Subject: Applicant's Response to PVID Comments on Preliminary Staff Assessment
Rio Mesa Solar Electric Generating Facility (11-AFC-4)

RE: TECHNICAL MEMO, BRIGHTSOURCE RESPONSE TO PVID COMMENTS

DATE	21 December 2012
TO	TECHNICAL MEMORANDUM
FROM	Mark Trudell, Ph.D., PG, CHG
COPY	Michael Rojansky
PROJECT NAME	BrightSource Rio Mesa Groundwater Resources Impact Assessment
PROJECT NO.	
SUBJECT	Response to PVID Comments on the Preliminary Staff Assessment
FILE LOC.

TECHNICAL MEMORANDUM

GROUNDWATER PUMPING AND RECHARGE
ON THE PALO VERDE MESA

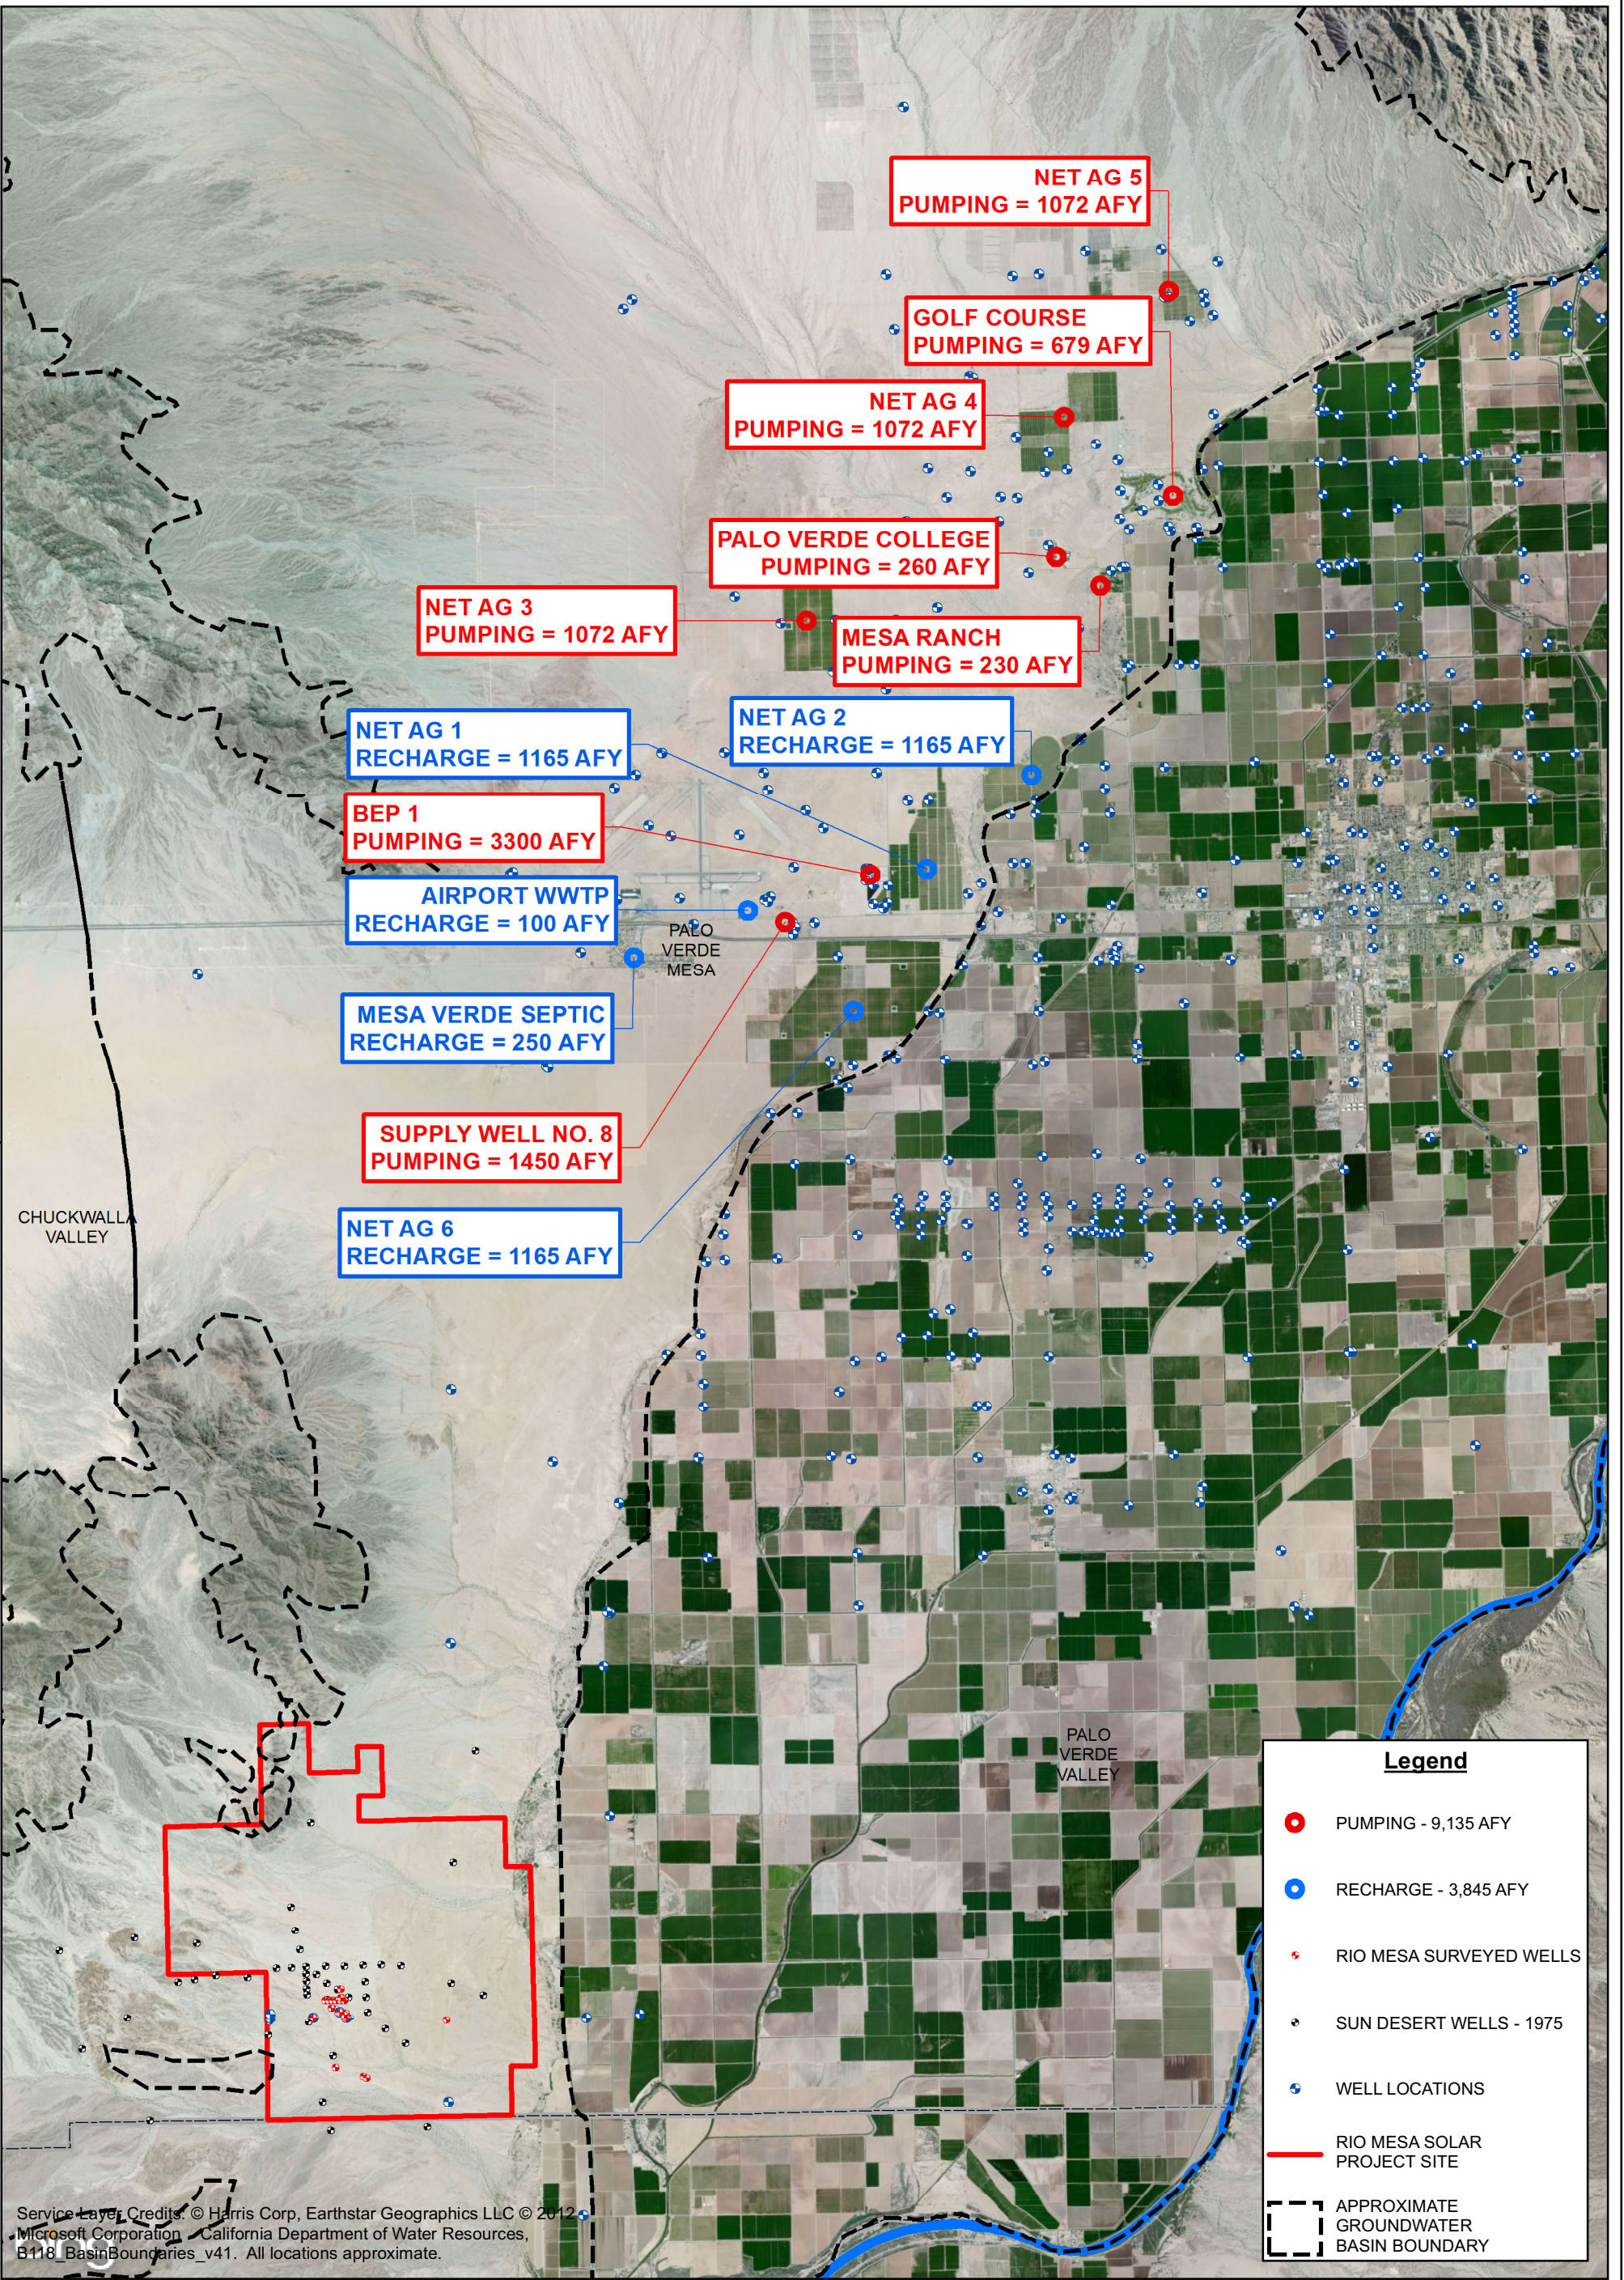
- PVID Comment 8: This comment presents updated water balance information. Based on PVID's historical knowledge, records and responsibilities in the PVVGB and the PVMGB, this information is considered to be definitive and reliable. It is discussed in greater detail in a subsequent section of this memorandum.

1. Pumping and deep percolation recharge on the Palo Verde Mesa, as described above in the revised RMS water balance, was added to the model. Net agricultural (Ag) pumping or recharge, and other institutional and commercial pumping and deep percolation recharge were added to model, as summarized in Table 3. The location and quantities of these flows are shown in Figure 2. These flows were introduced to the model as steady-state well boundary cells. The net pumping that resulted from this revision reduced heads in the northern part of the Palo Verde Mesa, which required additional adjustment (lowering) of layer 1 bottom elevations in the mountain front areas to avoid dry cells.

Note: Refer to Figure 2 for locations of pumping and recharge

RIO MESA SOLAR POWER PROJECT		 WorleyParsons resources & energy		
DRAWDOWN CONTOUR MAP REVISED RMS IMPACT MODEL		SWL	MT	11/2012
		308038-03598		3

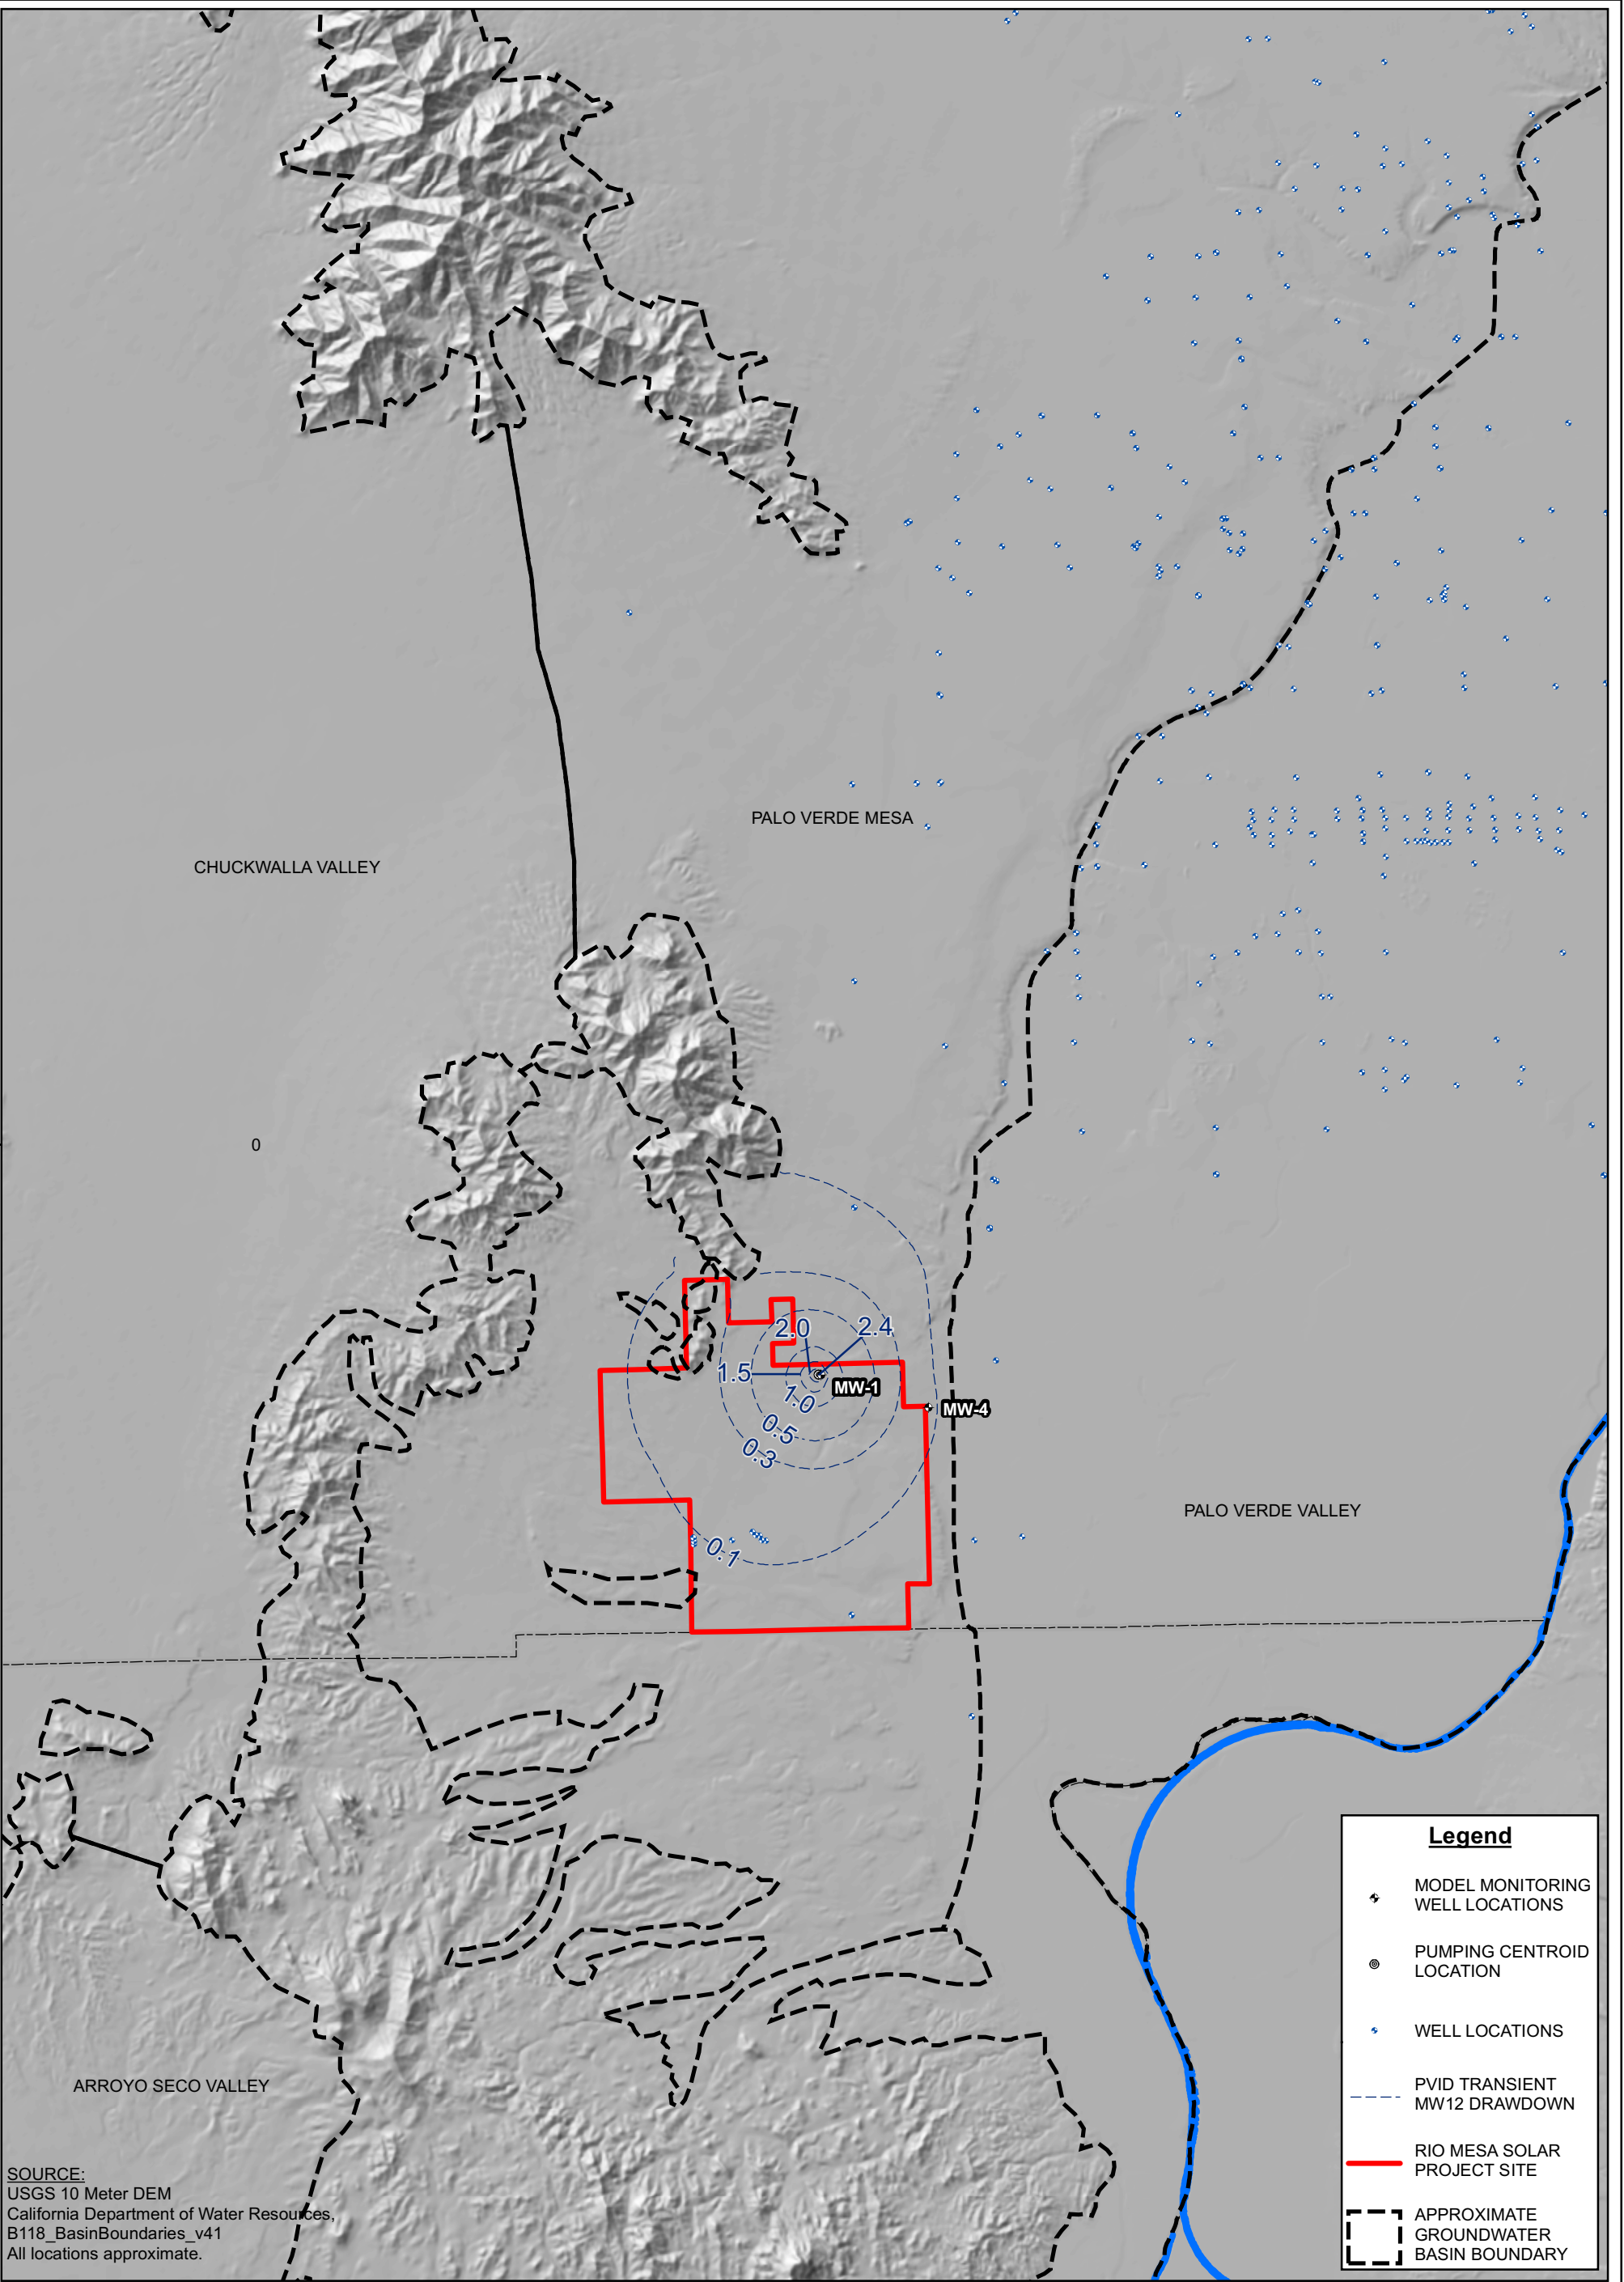
- PVID Comment 10: PVID indicates that an important potential effect of the RMS project that must be evaluated is the potential for groundwater pumping to reduce the amount of flow in Hodges drain by intercepting groundwater that would otherwise discharge there. We concur with this position. An evaluation of the project's effect on flow in Hodges Drain was presented with the AFC, and this memorandum presents an updated assessment.

Figure 3 shows the project related drawdown predicted by the Revised RMS model. The model results show that project-related drawdown impacts will be less than significant. Consistent with previous model results provided to the CEC, drawdown decreases rapidly away from the pumping wells in the Revised RMS model and is similar in extent to previous model results. The revised model predicts that the 0.1 ft drawdown contour to the east of the RMS wells will not extend from Palo Verde Mesa Groundwater Basin into the Palo Verde Valley Groundwater Basin.

The maximum predicted drawdown will occur near the pumping wells for the project at the end of construction pumping when operational pumping also start, in first quarter (Q1) 2016, and is predicted to be approximately 9.6 feet. After construction pumping finishes, operational pumping decreases to 173 AFY and groundwater levels near the pumping wells will recover while the overall drawdown cone continues to expand. The maximum lateral extent of predicted drawdown will occur at the end of project operation. At the end of project pumping, the maximum predicted drawdown near the project wells is 3.8 feet in the Revised RMS model. Drawdown is predicted to be less than 1 foot at distances greater than 0.4 mile from the pumping wells at the end of project pumping. Measurable drawdown is not predicted to extend westward beyond the site boundaries. Drawdown beneath the undeveloped land immediately north of the site is predicted to be approximately 2 feet near the site boundary and decreasing rapidly northward to 0.3 feet or less at a distance of about 1 mile from the site.
